SPRUCE AVENUE PEAKS ISLAND
85-G-2

Spruce Ave., Peaks Island

June 8, 1965

In checking your application to construct a 1-story frame addition 8'x9'-6" in front jog of building we find that we are unable to issue this permit because the new addition would exceed maximum building area allowed in the R-3 Zone. The building area in the R-3 Zone in which this property is located (Section 4-B-6 of Zoning Ordinance) is restricted to 25 per cent of lot area.

PLOT PLAN

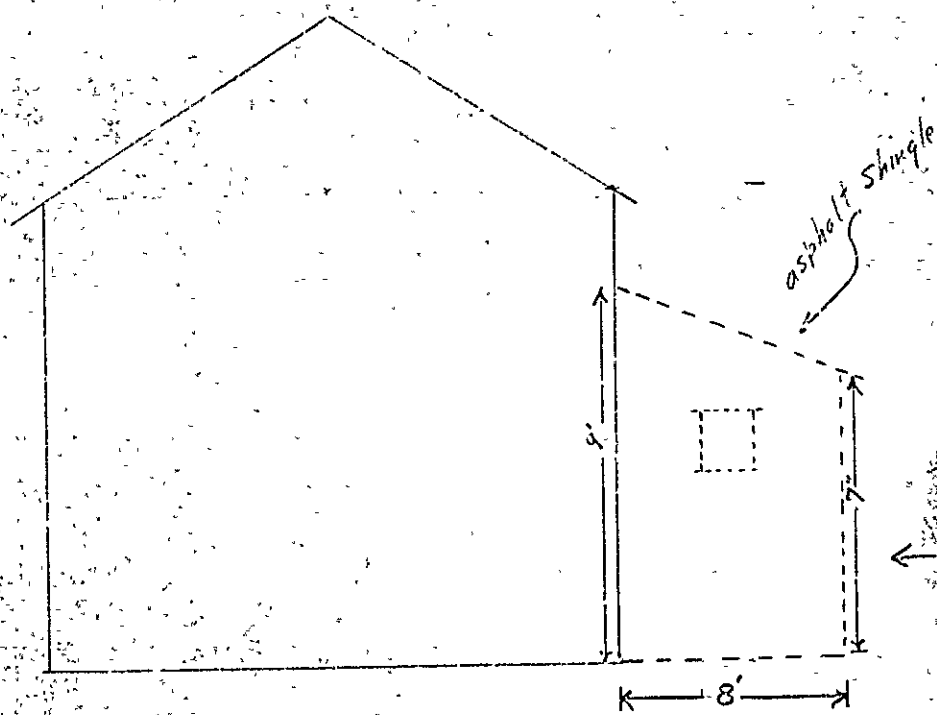
We see on the plot plan that was submitted by the contractors that existing camps on the same lot are expected to be torn down shortly. If a permit was applied for to do this work and the building was then demolished we could then proceed to issue this permit to build a new addition. If this is not to be done now, the only other recourse would be to appeal to do this work. If this is your desire please let us know so that a certification letter can be written denying your permit and explaining the necessary procedure for you to take.

→ Building Area - 1,100' Buildings 1,990' + addition 76' - Total 2,066'
